December 9, 2022

SOLICITATION ADDENDUM NO. 1
ITB 22-0018
Classroom Walls- Phase 3

DRAWING REVISIONS

READING ROOM - DEMOLITION RCP - ELECTRICAL

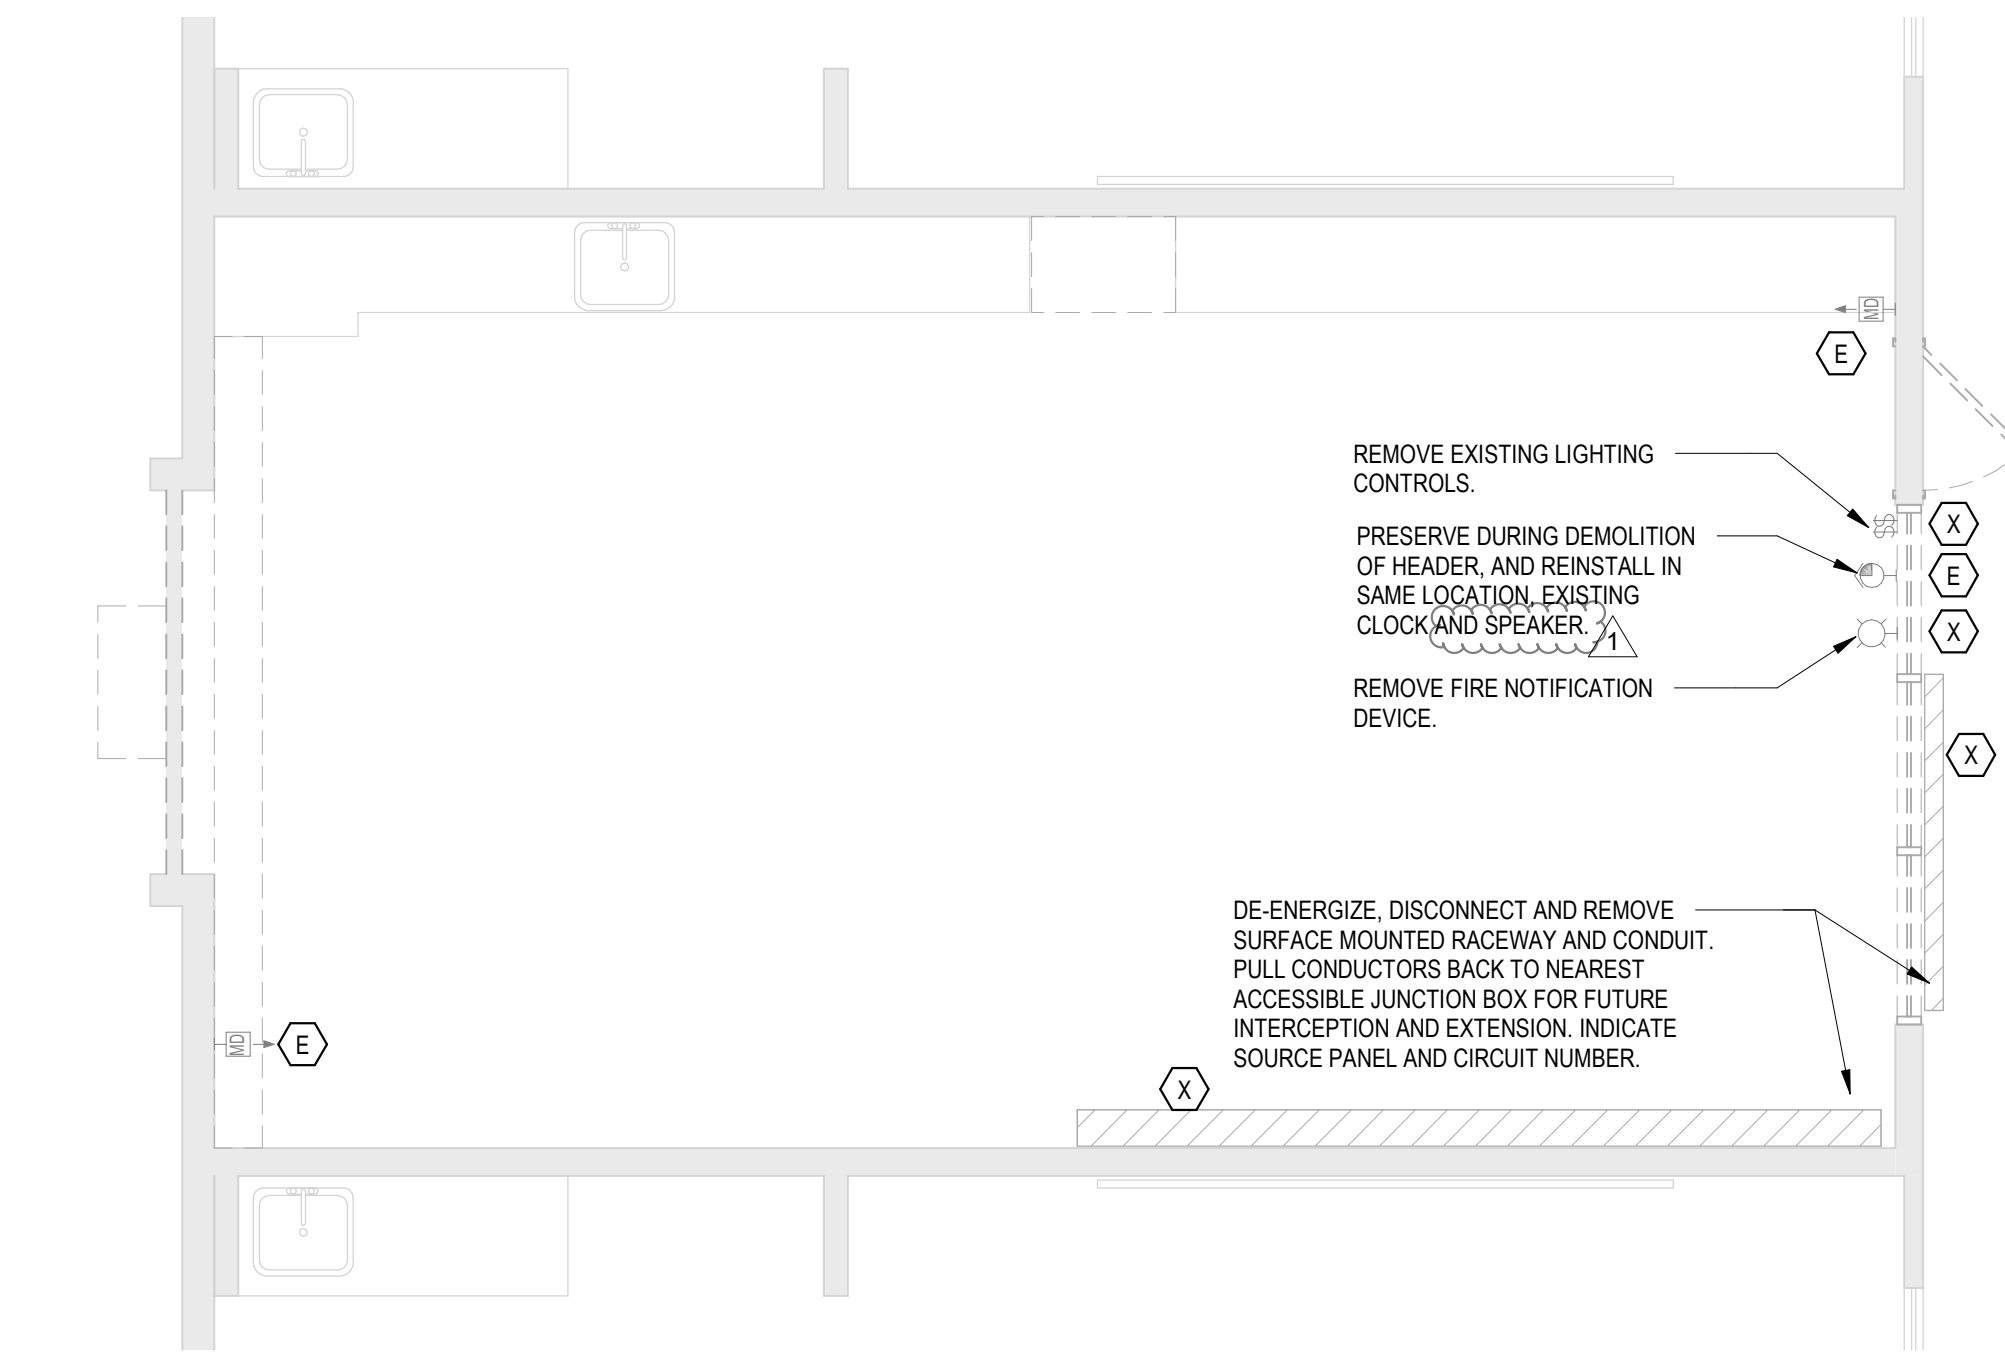
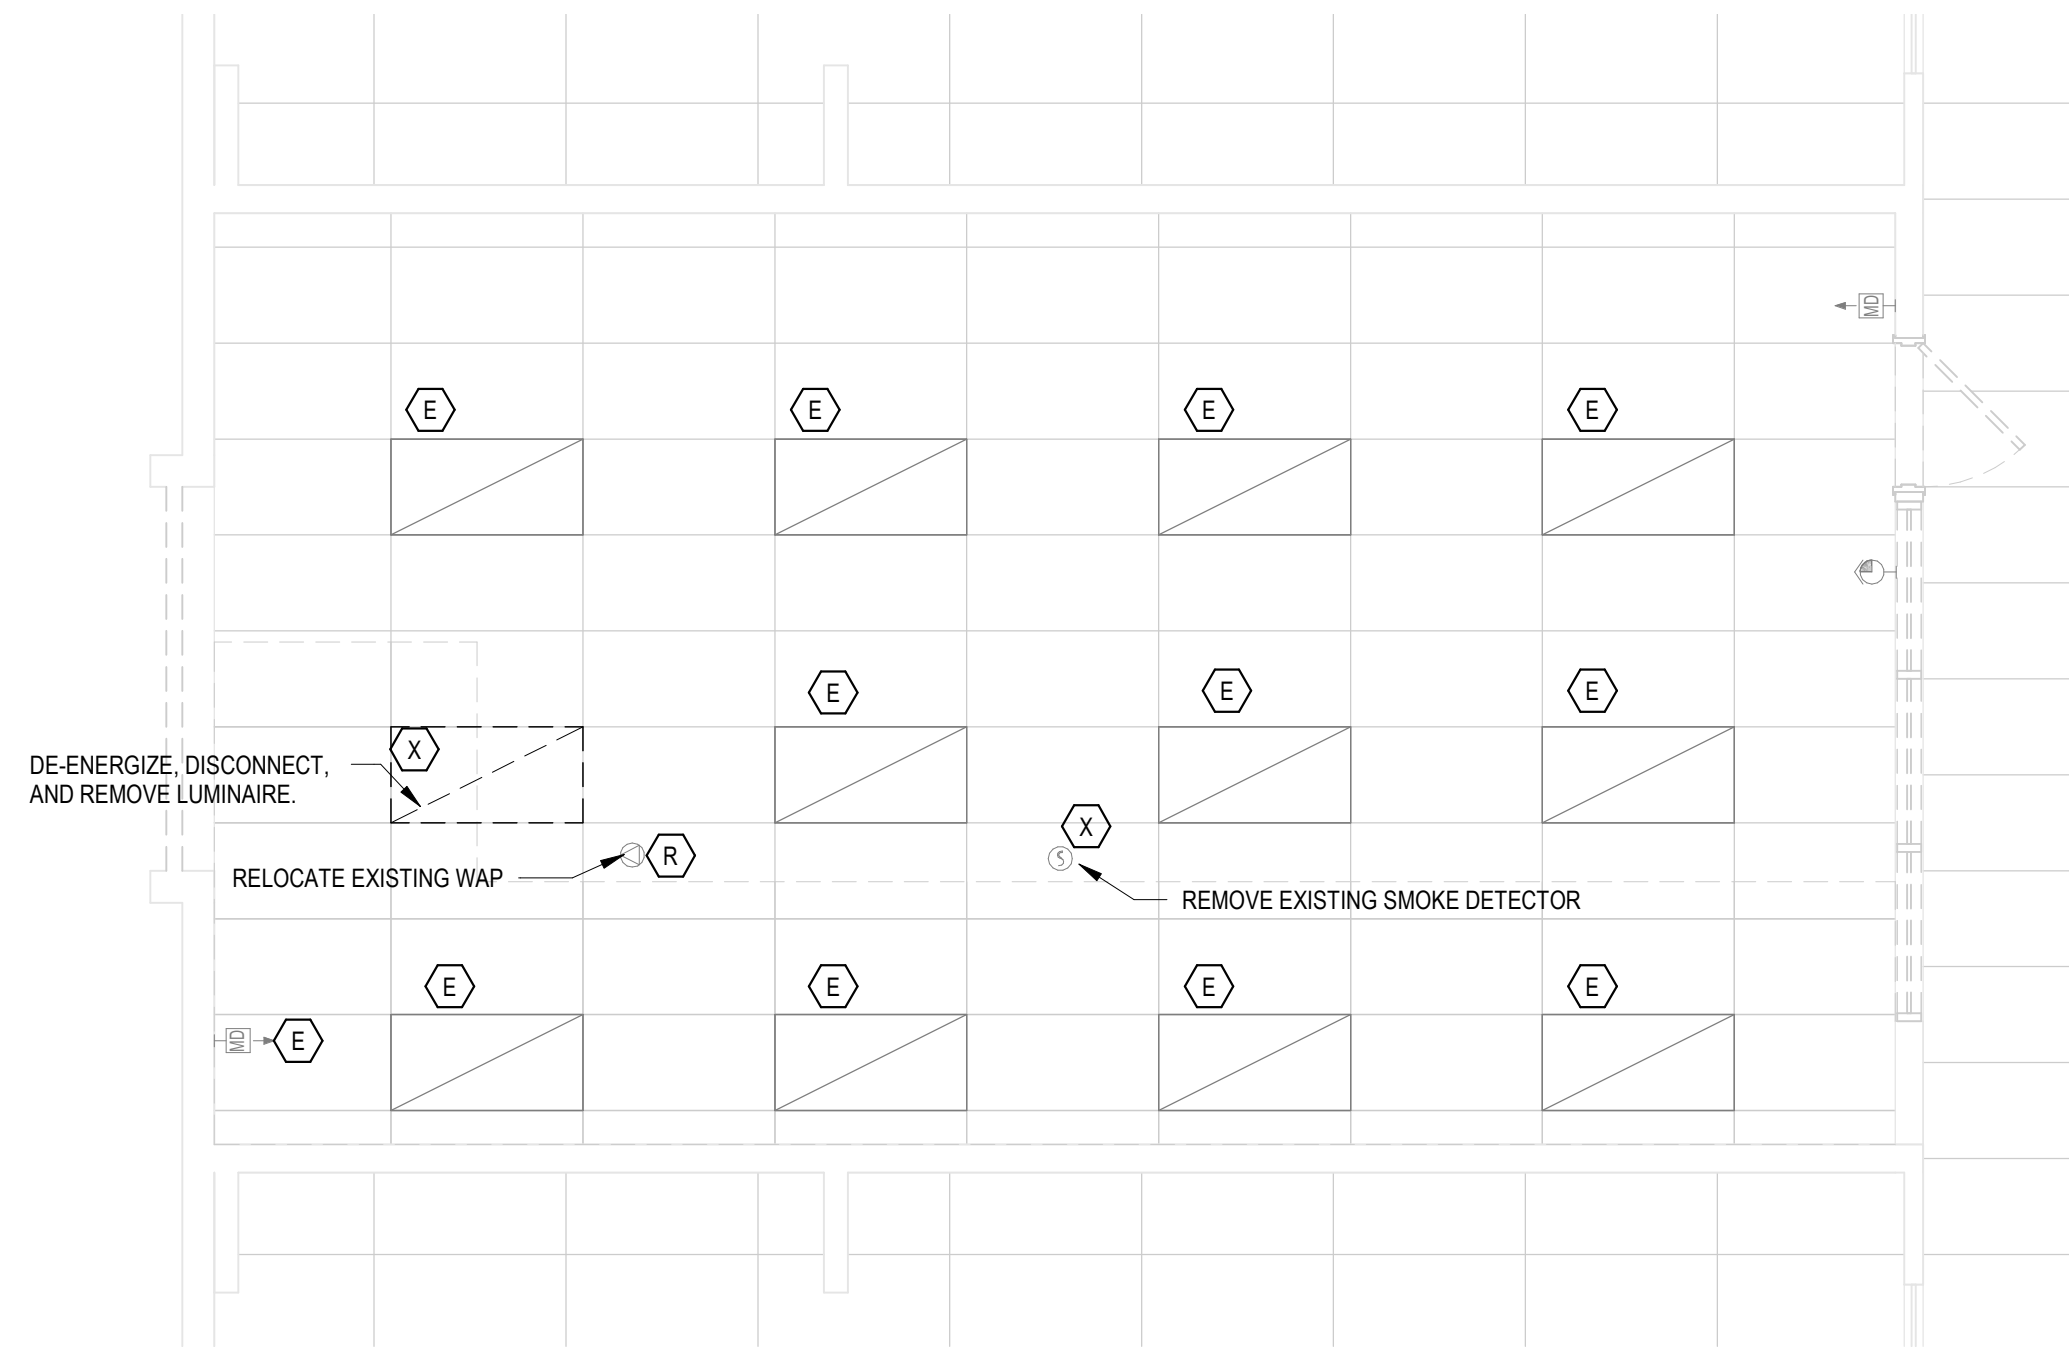
2. E301 - ENLARGED PLANS - READING ROOM ELECTRICAL
 - a. Additional keynotes and information are included to capture emergency lighting
